Addendum 1 for RFP #917700-001

Project Name: ILEA Parking Lot Replacements

Date: 11/12/2020

1 EXTERIOR LIGHTING CONTROL DETAIL
NO SCALE

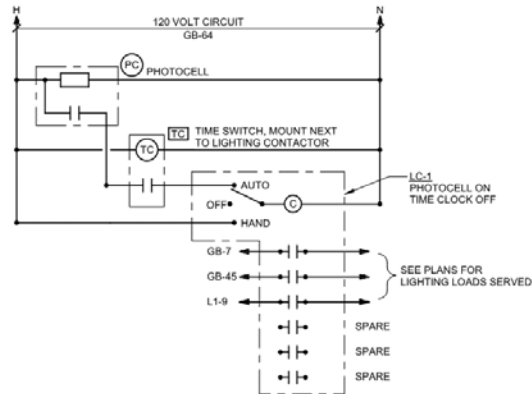
- 3.6.1 It is anticipated that the design firm would provide recommendations for consideration by ILEA and DAS.
- 3.7 Where is the source of power and what is the voltage?
 - 3.7.1 Light poles are 120V fed from the North most pole by an underground conduit routed West into the building and into the electrical room.
- 3.8 Will a new control cabinet need to be installed?
 - 3.8.1 Exterior lighting is already on controls. It is not anticipated that a new lighting control cabinet would be required. See below lighting control detail.
